Salem Generating Station, Unit 1
Renewed Facility Operating License No. DPR-70
NRC Docket No. 50-272

Subject: **Response to Integrated Inspection Report 05000272/2017003 and
05000311/2017003**

Administrative Controls Related to Salem Unit 1 Containment Isolation Valves

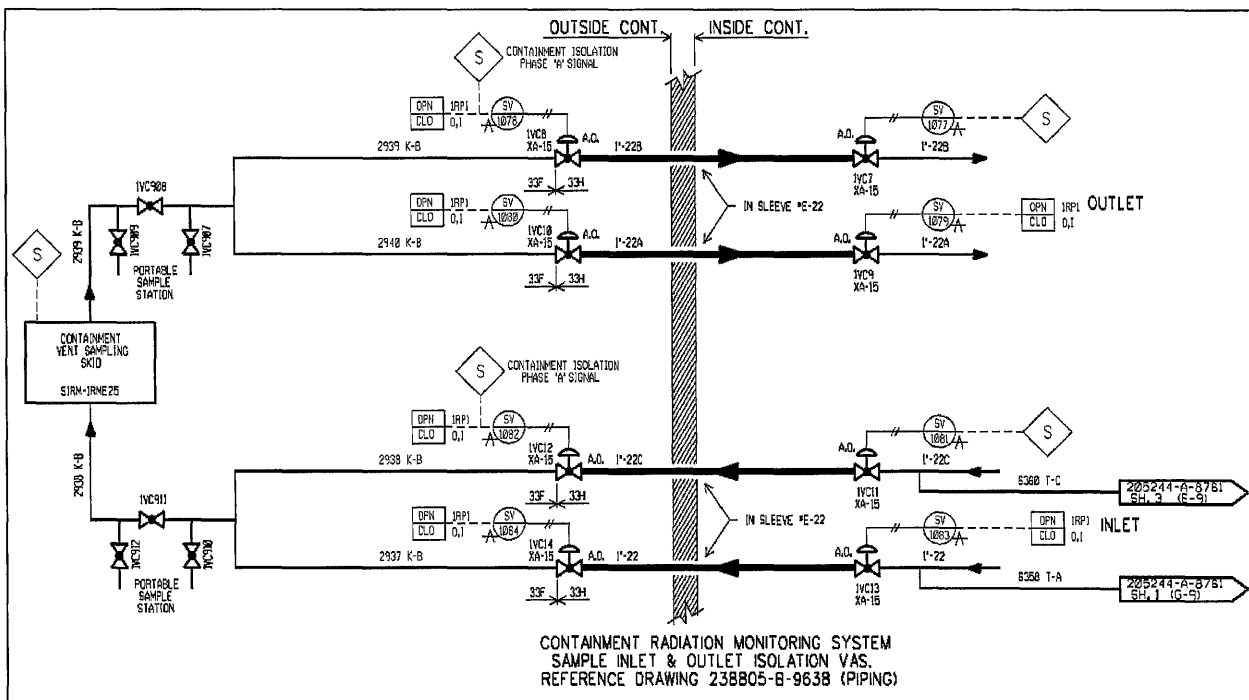
The containment APD monitors for the presence of radionuclides in the containment atmosphere. The actual radiation monitor is located outside of containment and is supplied with containment air through one inch diameter sample lines. The sample lines are equipped with normally open air operated CIVs identified as 1VC7, 8, 11 and 12 that automatically close in response to accident conditions. A parallel flow path is provided that is equipped with normally closed air operated valves (AOV) identified as 1VC9, 10, 13 and 14. These are the 'manual CIVs' the NRC refers to. These manual CIVs can be closed remotely from the control room by operation of a switch.

The flow paths are illustrated below. The containment ventilation sampling skid identified below as S1RM-1RME25 contains both the APD and a gaseous radioactivity (radiogas) monitoring system. Isolating air flow to the skid disables both monitoring systems.

As described in the contested NCV, CIVs 1VC7, 8, 11 and 12 (the "automatic CIVs") were closed to support work on an unrelated radiation monitor. CIVs 1VC9, 10, 13 and 14 (the "remote-manual CIVs") were opened to allow the containment APD to continue operating. This configuration was entered pursuant to a clearance and tagging document that mandated placement of information tags to alert control room operators that the automatic CIVs were disabled and that the remote-manual CIVs needed to be closed in the event of an accident. This was a planned maintenance activity that began on December 8, 2016 and was successfully completed on January 4, 2017.
